Re ZC Case 14-13 – Text Amendments to Multiple Chapters Affecting Definitions, Use
Permissions, Size and Other Attributes of Rooftop Penthouses and Other Elements

ZONING COMMISSION
District of Columbia
ZONING COMMISSION
CASE NO. 14-13
EXHIBIT NO. 78

Below see images of typical elevator profiles (extracted from <http://www.archtoolbox.com/materials-systems/vertical-circulation/elevatortypes.html>):

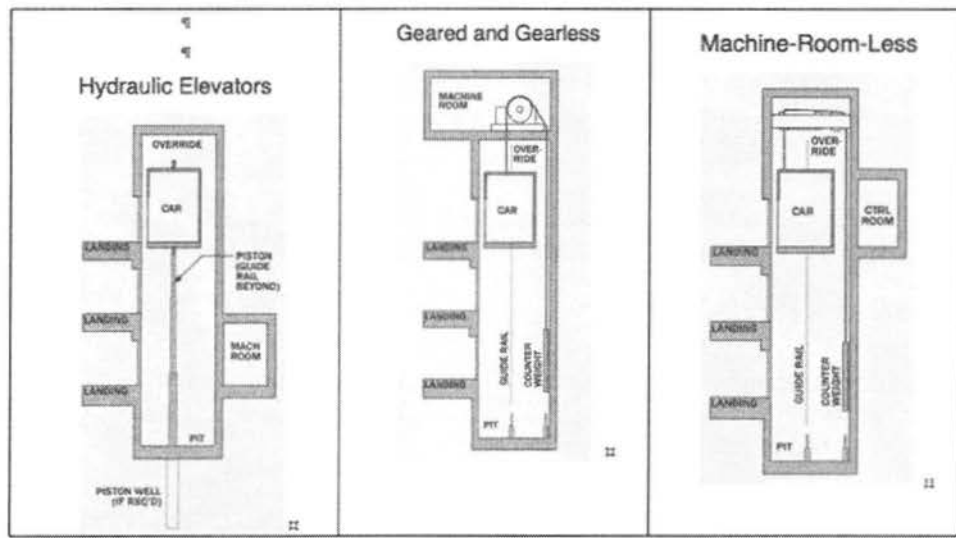
of the roof. This is so close to the existing allowed maximum, I would have to question of taking away just thirty inches (30") accomplishes much. Given setback rules that would already apply, designers will want to keep verticals to a minimum to allow placement as close as possible to building edges and have as consistent a height of elevator overrides with any other roof structures housing stairways, mechanical equipment, or other allowed uses..

Please note that in the above diagrams, all the overrides have a flat roof. I recommend that the Zoning Commission allow sloped roofs that rise above this plane when they are associated with a building whose other main roof surfaces slope so the resulting roof structure can be more compatible with the building of which it is a part by right, at the discretion of the Zoning Administrator, if the uppermost flat portion is or could have been flat and complying with height limits.
